1989 Corvette: Service Bulletin: Tire Rotation Procedure

Subject: Tire Rotation Procedure

Model and Year: 1989 Y Car with Optional Low Tire Pressure Warning System

Number: 89-299-3E

Figure 1 - Tire Rotation Pattern

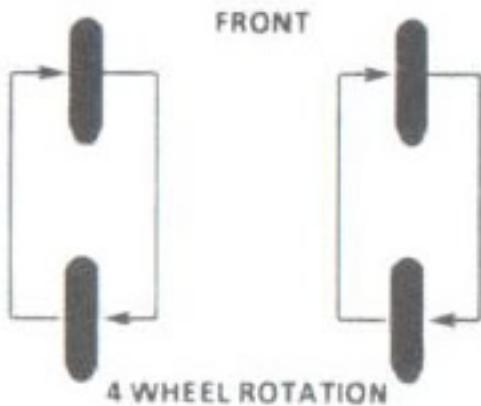
The Low Tire Pressure Warning System receiver does not recognize wheel/tire assembly location; however it does look for a particular signal from each of the four wheel transmitter/sensors. Therefore, the procedure given on the tire rotation in Section 3E of the 1989 "Y" Carline Service Manual should be disregarded. The tire and wheel assemblies on vehicles equipped with the optional Low Tire Pressure Warning System can be rotated as shown in Figure 1.

ACCEPTABLE ROTATION PATTERN
DO NOT ROTATE TIRES ON ZR1 SPECIAL
PERFORMANCE COUPE

DO NOT INCLUDE
"TEMPORARY USE ONLY"
COMPACT SPARE TIRE IN ROTATION
